Piper Aircraft, Inc.
2926 Piper Drive
Vero Beach, FL, U.S.A. 32960

SERVICE NO. 1429A BULLETIN

TRIM CABLE PULLEY RELOCATION

PURPOSE: THIS REWORK PROVIDES INSTRUCTIONS ON RE-INSTALLATION OF PULLEY ^(A)
MOUNTING BRACKET ASSY TO RE-ENABLE CABLE TENSION VALUES

FIGURE 1. EQUIPMENT/FURNISHINGS PARTS TO BE REMOVE AND RE-INSTALL

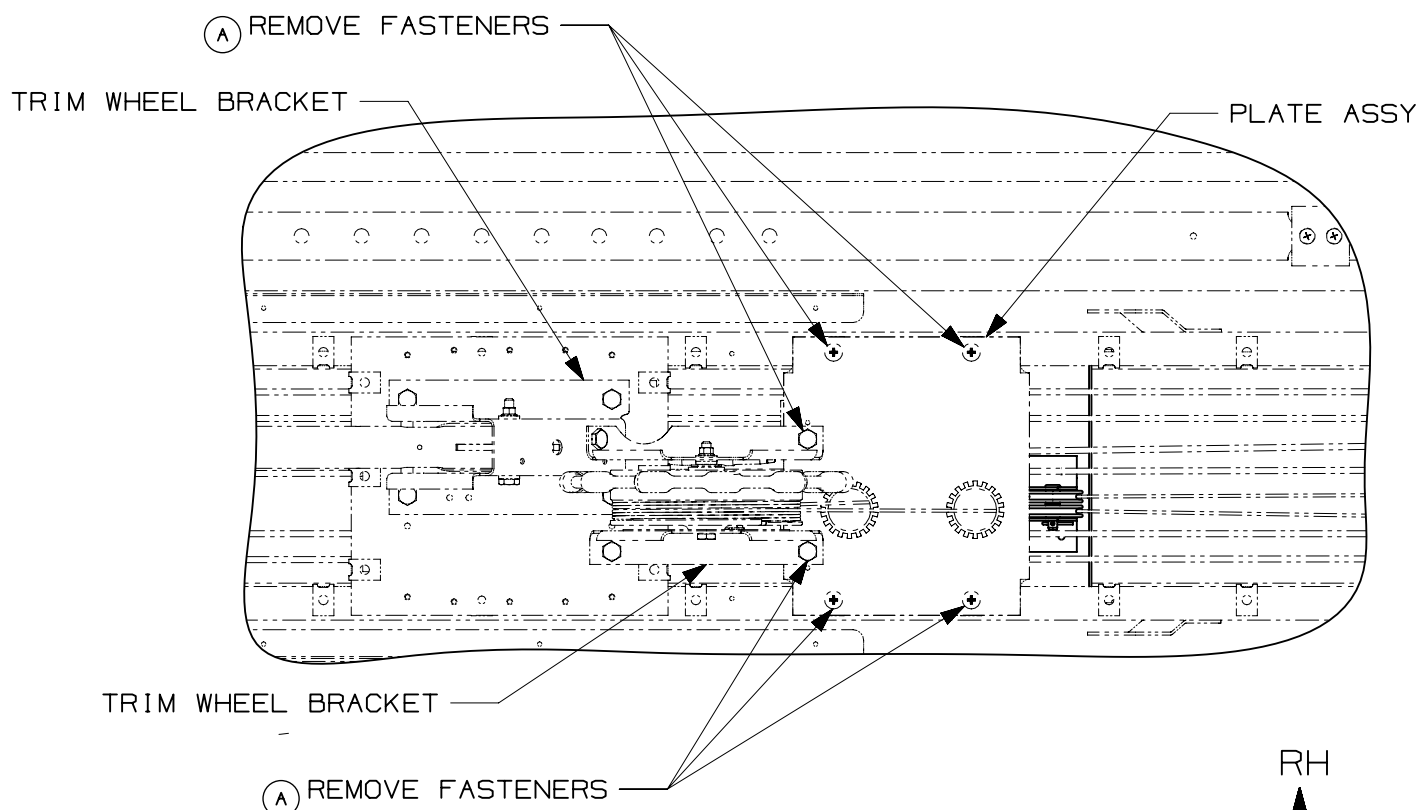
1. REMOVE THE PILOT, CO-PILOT SEATS, AND FORWARD CENTER SEAT BELT. (A)
(REFERENCE FIG. 1)
2. REMOVE THE FOLLOWING ASSYS AND HARDWARE TO GAIN ACCESS TO THE PULLEY MOUNTING BRACKET; (A)
FIRE EXTINGUISHER ASSY (82235-002)
COVER ASSY (28F250045-003 - ARCHER, 67785-017 - PILOT)
FLOORING MATERIAL, CARPET ASSY (76160-007 - ARCHER)
OR
COVER ASSY (28F25V001-032 - PILOT)
PLATE ASSY (76121-000)
(REFERENCE FIG. 1)

FIGURE 2. STABILATOR TRIM PARTS TO BE REMOVED AND RE-INSTALLED (A)
SCALE 1:4

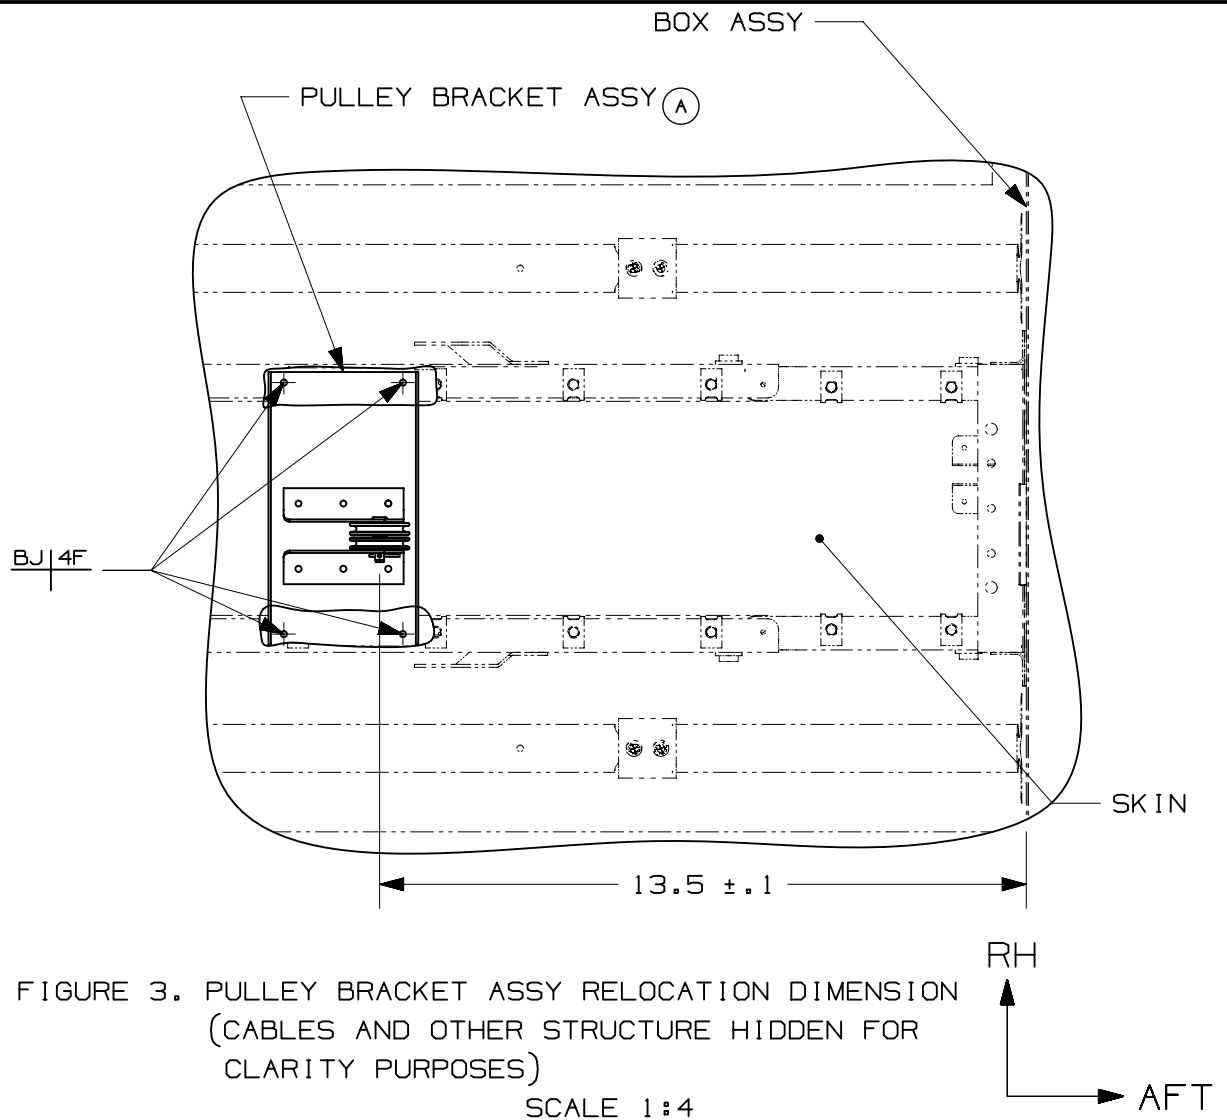
3. REMOVE FASTENERS THAT HOLD PLATE ASSY (28F270001-003) TO TUNNEL ASSY (A)
(28F53A185-001) AND TRIM WHEEL BRACKETS (65633-000 AND 65635-000).
(REFERENCE FIG. 2)

7. RE-INSTALL AND TIGHTEN PLATE ASSY (28F270001-003) AND TRIM WHEEL BRACKETS (A)
(65633-000 AND 65635-000) TO THE TUNNEL ASSY (28F53A185-001).
8. RE-TENSION CABLES PER MAINTENANCE MANUAL INSTRUCTIONS. CAREFULLY INSPECT
CLEARANCES FOR THE ENTIRE CABLE RUN, WHILE OPERATING THE CONTROL SYSTEM.
ENSURE CLEARANCE TO FIXED STRUCTURE FOR ALL CABLES AND CABLE FITTINGS
THROUGH THEIR FULL TRAVEL.
